PLANNING DIVISION STAFF REPORT

Project Name/Address: 1239 Spaight

Application Type: PUBLIC HEARING
Demolition and new construction in the Third Lake Ridge Historic District

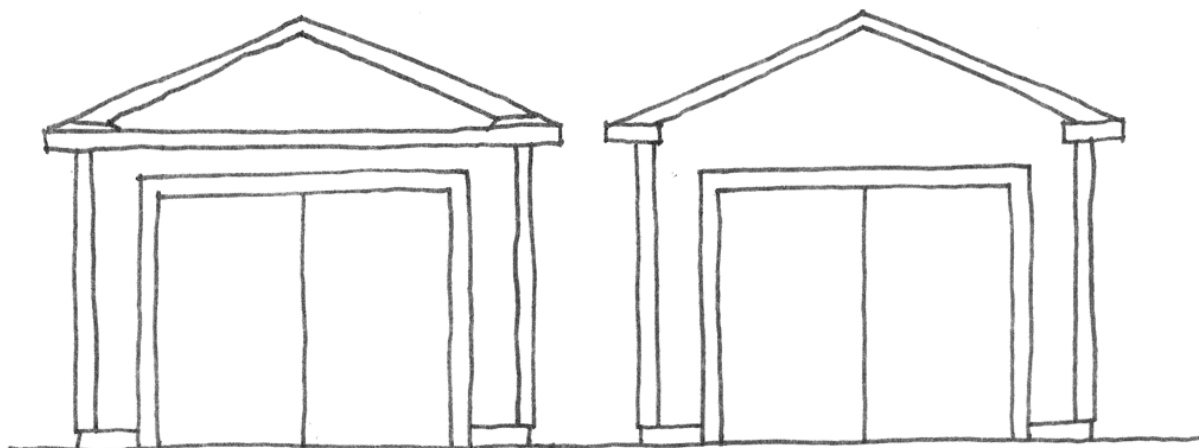
- (d) Please review discussion of (h) below.
- (e) The proposed building has a gabled roof which is similar to the roof forms present on numerous buildings in the area of visual compatibility and to the roof of the primary building although the pitch is lower than the roof pitch of the primary building. In addition, the elevation drawing shows a closed pedimented gable form which should be simplified to remove the horizontal eave and allow the soffit and fascia to return up the gable at an angle.

1. If operable windows are desired, the proposed windows shall be changed to awnings of similar appearance or to one over one double hungs. The fixed windows in the doors can remain as proposed.
2. The siding shall be changed to not include faux wood grain.
3. The gable roof form shall be simplified by removing the pedimented gable.
4. The roof material shall be changed to asphalt shingle.
